Project: **134-140 MARSDEN STREET,
PARRAMATTA (V BY CROWN)**

Report: **BCA ASSESSMENT REPORT**

Reference: **103823-BCA-r6**

Date: 13th August 2014

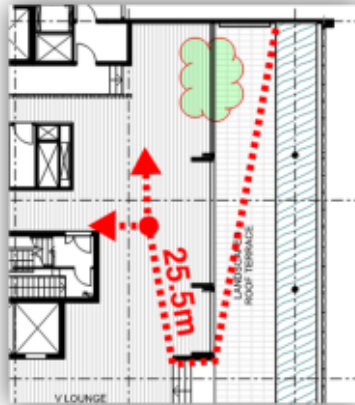
b) Unless provided with an additional exit pathway (as clouded) the travel distance from the Bar terrace on Level 26 indicated below appears to be 25.5m to a point-of-choice in lieu of 20m.

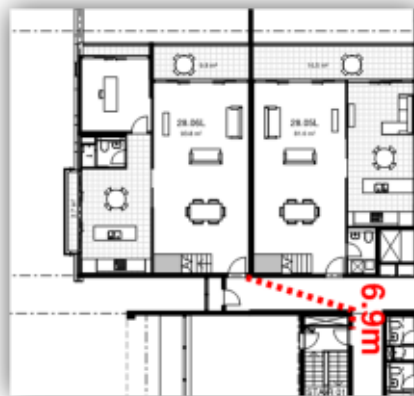
c) It is acknowledged that the doorway to Unit 28.6L at Level 28 is approx. 7m in lieu of 6m to the nearest fire stair, as shown below.

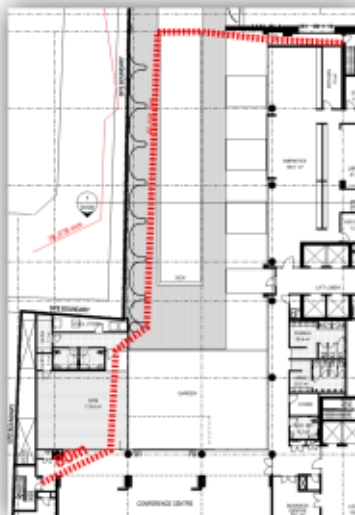
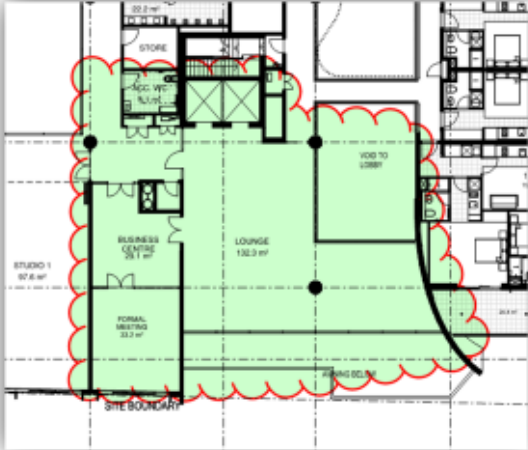
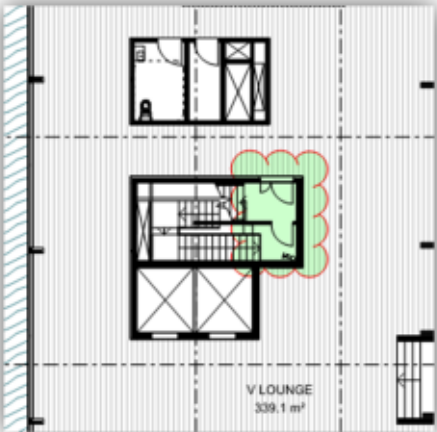
22. It is apparent that the distance between alternative exits at Level 1 in the vicinity of the external pool, (as the point of origin) is approx. 80m in lieu of 60m as required by this clause.

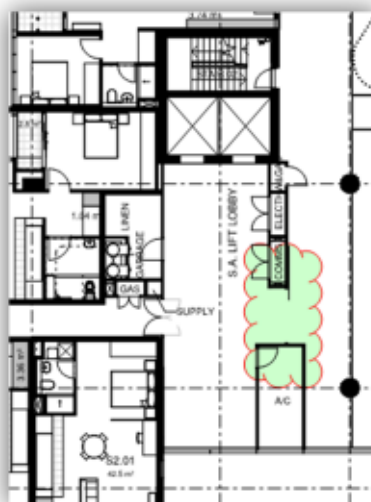
As discussed above, the Bar tenancy at Level 26 could accommodate up to 340 patrons (conservatively based upon 1m² per person) and 36 residents to the residential part at the same storey. Therefore the aggregate egress width from this storey is required to be at least 3.5m (accommodating up to 380 people).

It is evident that the two current proposed stairways on this storey provide at least 1m width each between handrails and is therefore in sufficient for the anticipated population for this storey.

It is anticipated that a fire-engineered alternative solution is to be prepared by the project's fire engineer to justify the egress width based upon more accurate occupancy loading. This is to be reviewed and confirmed pursuant of the detailed design stage.

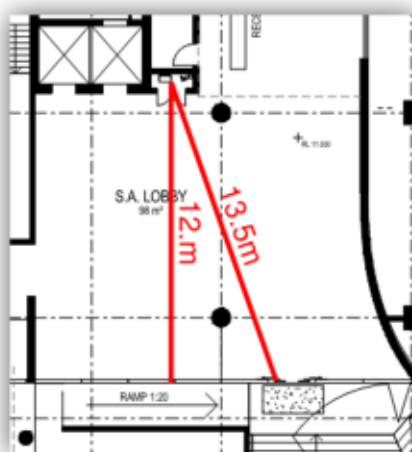
- a) On some levels the fire hydrant landing valves are shown to be outside the fire-isolated stairways, as a minimum a landing valve is to be provided at the floor level landing within each of the fire-isolated stairways.
- b) Furthermore, a number of additional fire hydrant points are shown throughout the building, these hydrant points are assumed to be additional points to ensure full

coverage of the building, this is to be confirmed by the design engineer as being in compliance with AS2419.1-2005.

Furthermore, it is noted that Fire hydrant coverage to the South west corner of the basement storeys is not achieved within 40m. Please have this verified by the hydraulic engineer pursuant the detailed design stage and if necessary consider an alternative solution to address this item pursuant of the detailed design stage.

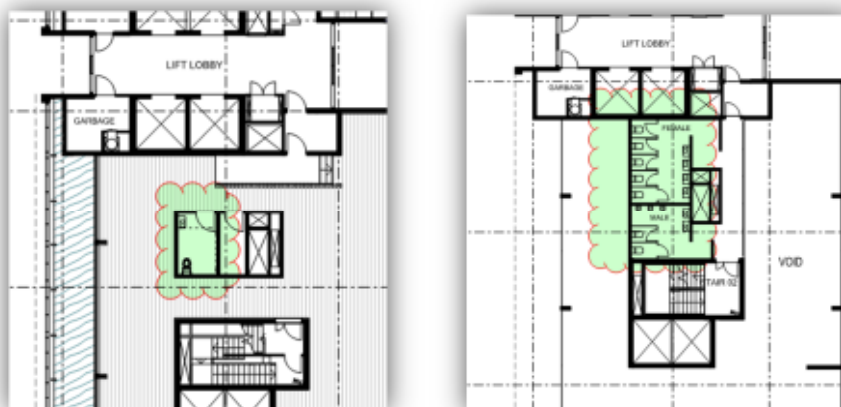
The Bar area at level 26 is provided with sanitary facilities. However, the allocation provided, as shown below, allows for the following male/female ratio:

Current sanitary facilities allow up to **150 male patrons** given that there are three (3) urinals proposed and using the concession allowed under clause F2.2 (c) where the unisex sanitary facility can be counted once for each sex.

Based upon an equal split of males and female patrons and using the population loadings as indicated under items 5.4 and 5.6 above it appears that the current proposed male sanitary facilities may be short of the calculated 340 patrons, (being 170 males).

Please provide the anticipated population of patrons for the Bar Area in order to determine compliance as part of the detailed design stage.
